Re: Indian Point Unit No. 2  
Docket No. 50-247

ATTACHMENT A

Responses to NRC questions  
on Inservice Inspection  
Program for Indian Point Unit No. 2

Figure 40-3

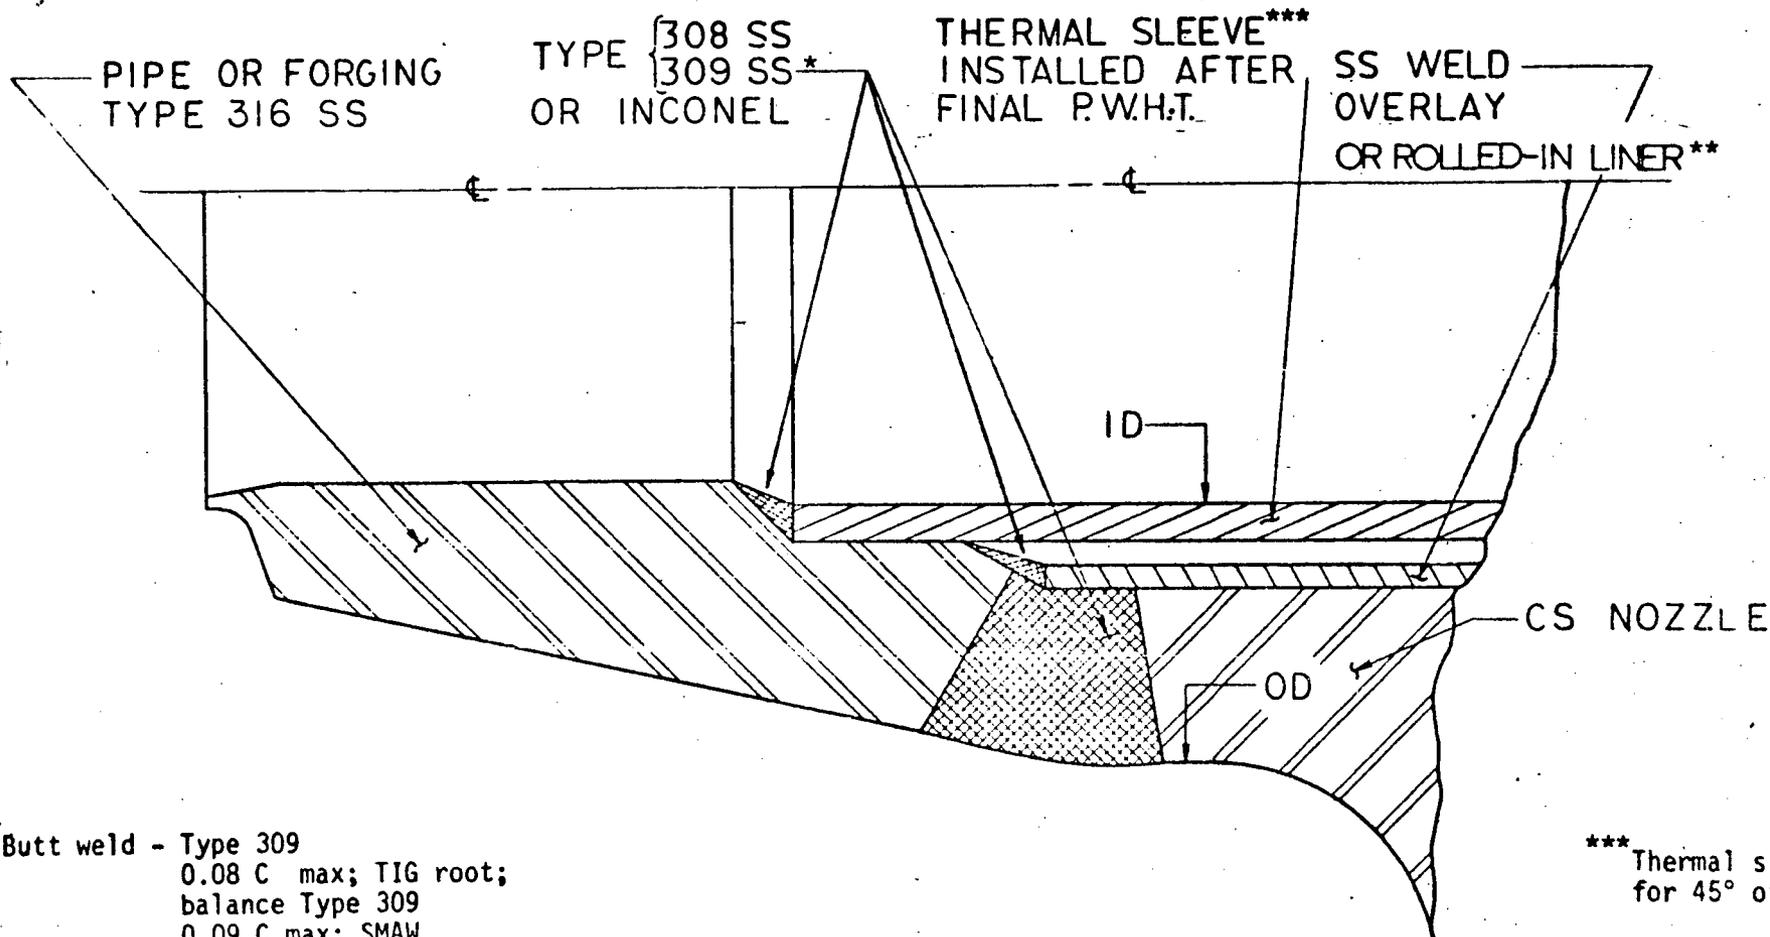
Item B2.4 Note 47 Page E1-16 (Reference 1)\*. Provide a sketch depicting typical pressurizer safe end welds for weld numbers PZRS 1, 2 & 6.

Attached is a sketch typical of the referenced welds.
